# City Commission Regular Meeting Agenda

**To:** City Commission  
**From:** Lupita McClenning, Planner  
**Meeting Date:** June 11, 2026  
**Item Name:** Final Site Plan Application PMS26-0002: Flagler Beach Vacation Rentals, 1708 S. Ocean Shore Blvd.; Parcel ID: 18-12-32-2750-00030-0030; Applicant: Theodore Barnhill; Request for final site plan approval to construct a three-story, eight-unit, oceanfront vacation rental apartment building in the Tourist Commercial Zoning District.

To: City Commission, City of Flagler Beach, FL  
From: Lupita McClenning, City Planner  
Date: May 6, 2026  
RE: Staff Report – 1708 S. Ocean Shore Blvd. - Site Plan

**To:** City Commission  
**From:** Lupita McClenning, Planner  
**Meeting Date:** June 11, 2026  
**Item Name:** Site Plan Application PMS26-0003: House of Crego, 2205 N. Oceanshore Blvd.; Parcel ID: 36-11-31-5630-00020-0110 ; Applicant: Brent and Evelyn Crego; Request Final Site Plan approval to construct a mixed-use building in the Tourist Commercial Zoning District outside the A1A Retail Corridor Boundary and Mixed-Use Overlay District.

LOCATION LAYOUT

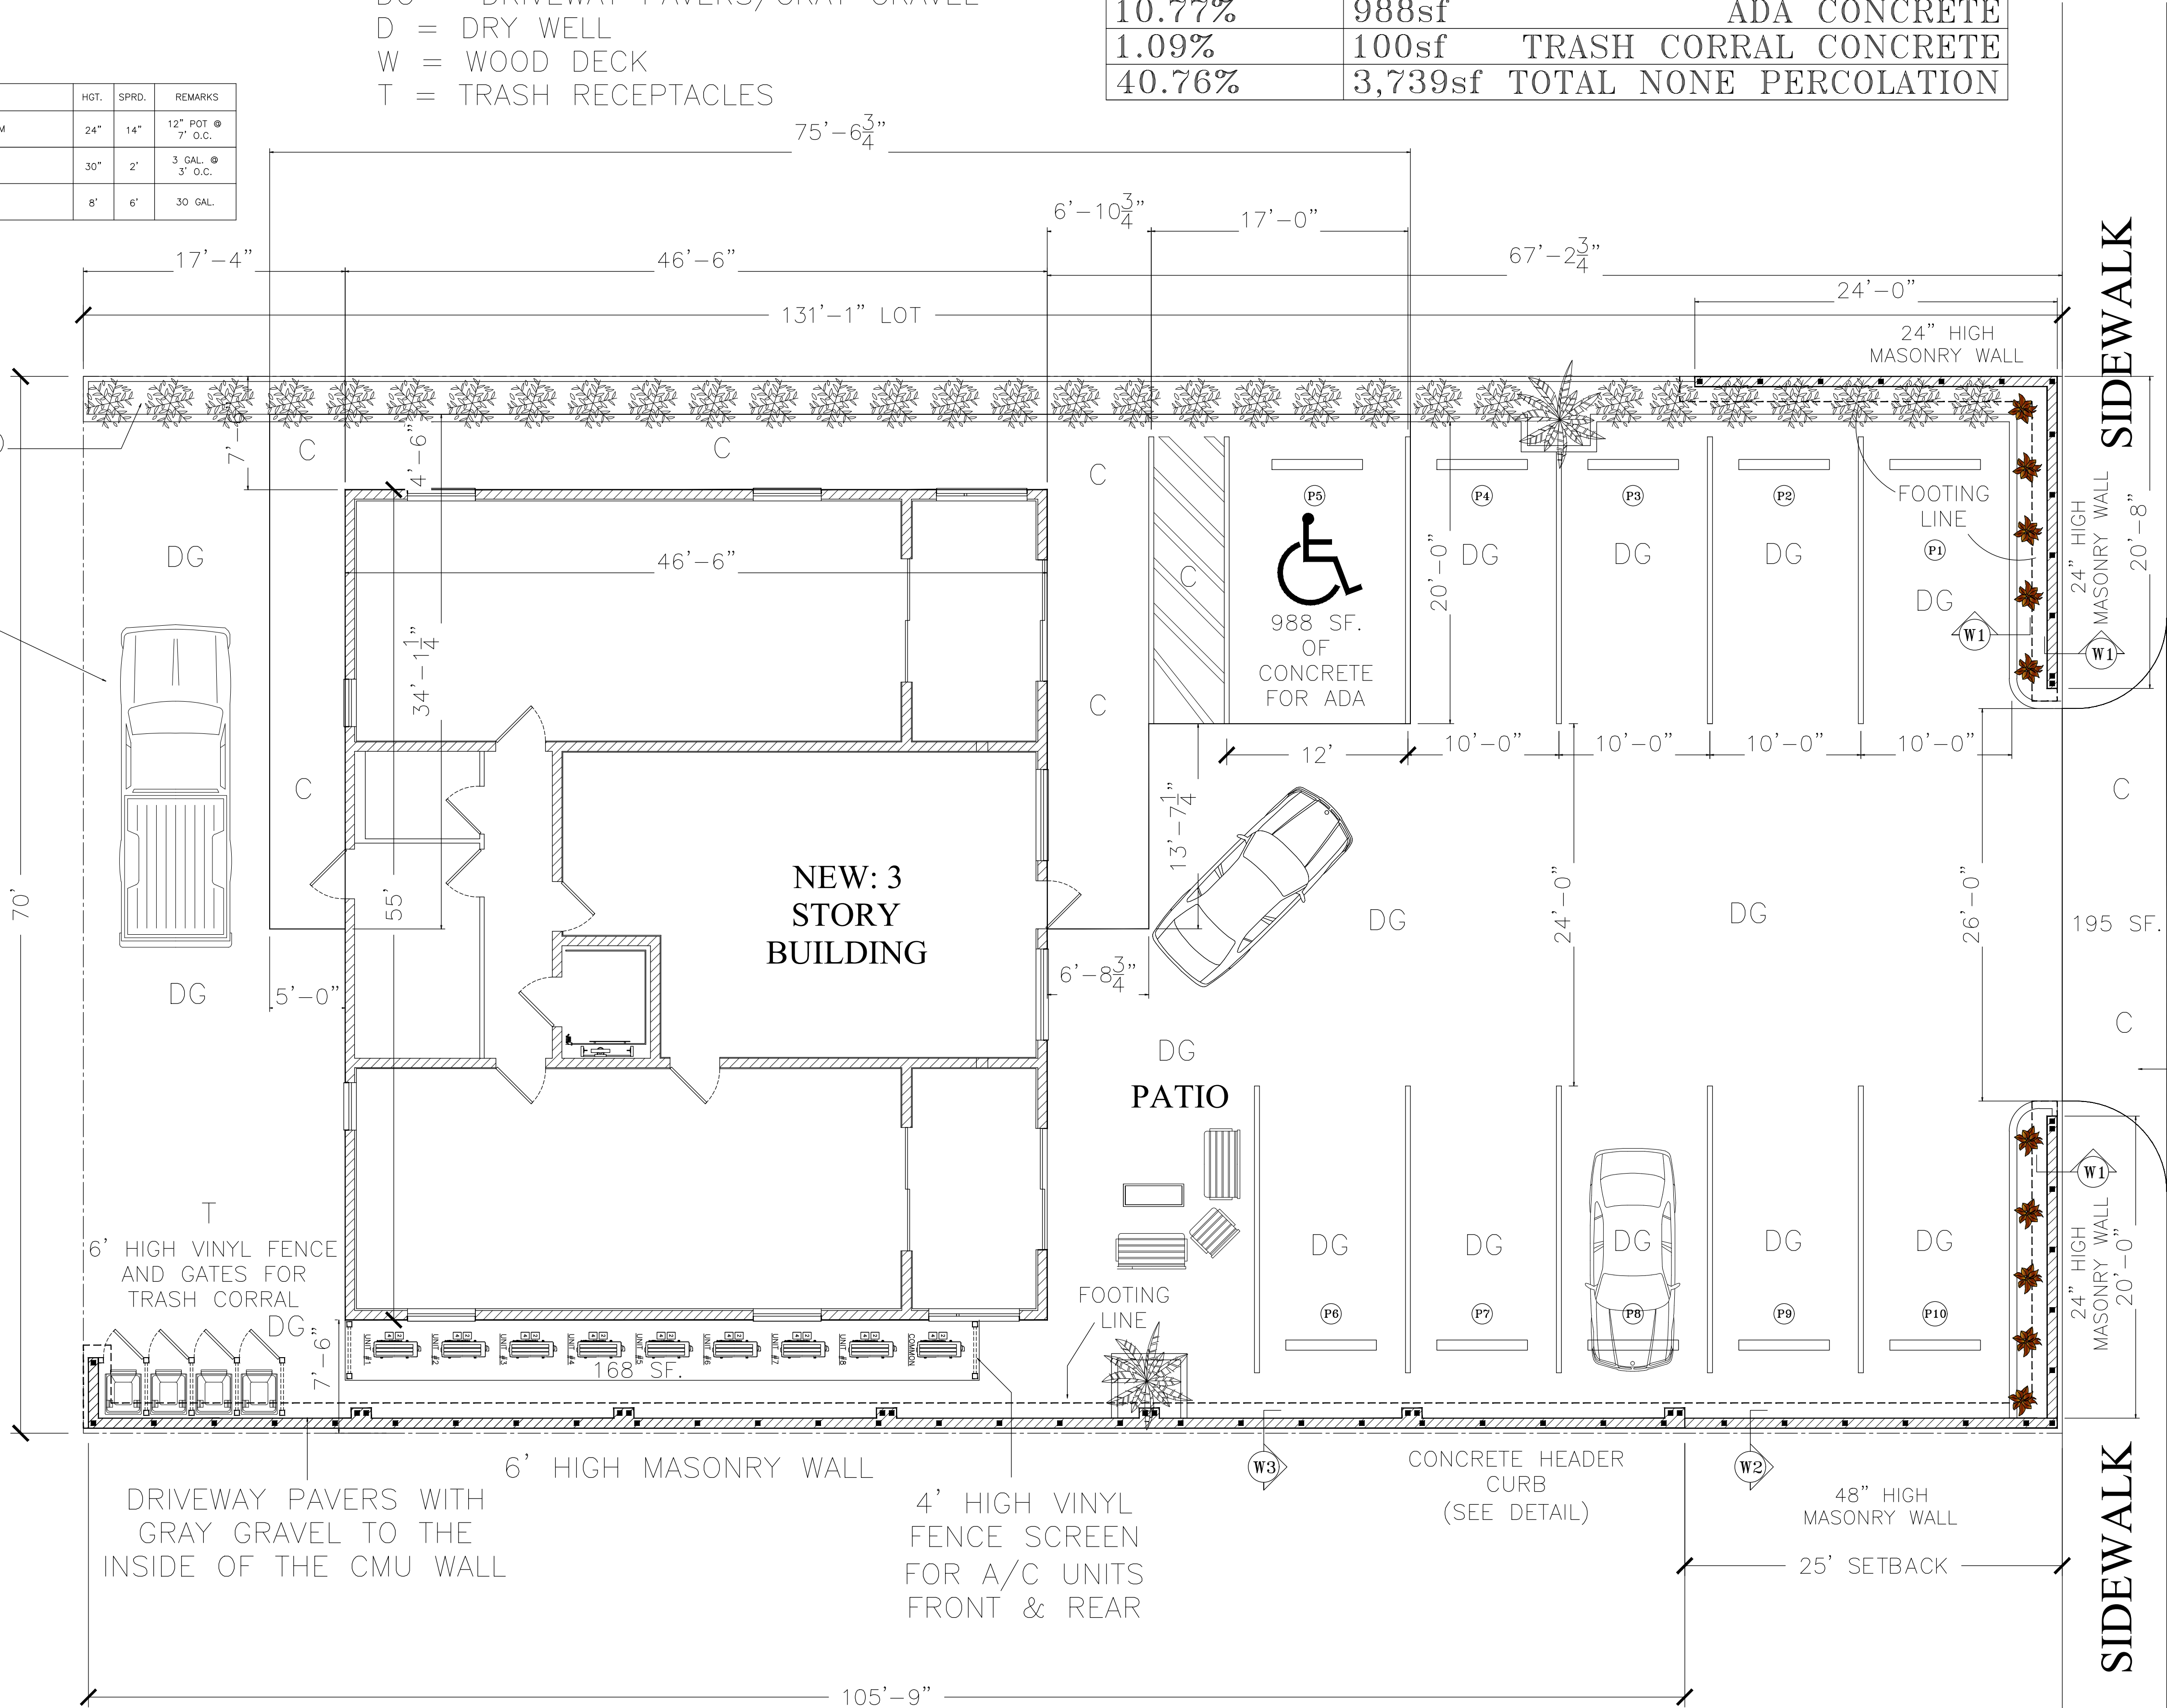
Staff recommends the City Commission approve the final site plan with the following conditions: replace 6' wooden fence on the south side with 6' masonry fence, screen the sanitation and HVAC units, and label the rear delivery parking area.

- That a 6' masonry wall on the south side of the property be reflected on the site plan vs a wooden fence;
- That the proper screening for sanitation and the HVAC units be reflected on the site plan; and
- That the rear delivery/parking area be labeled on the site plan.
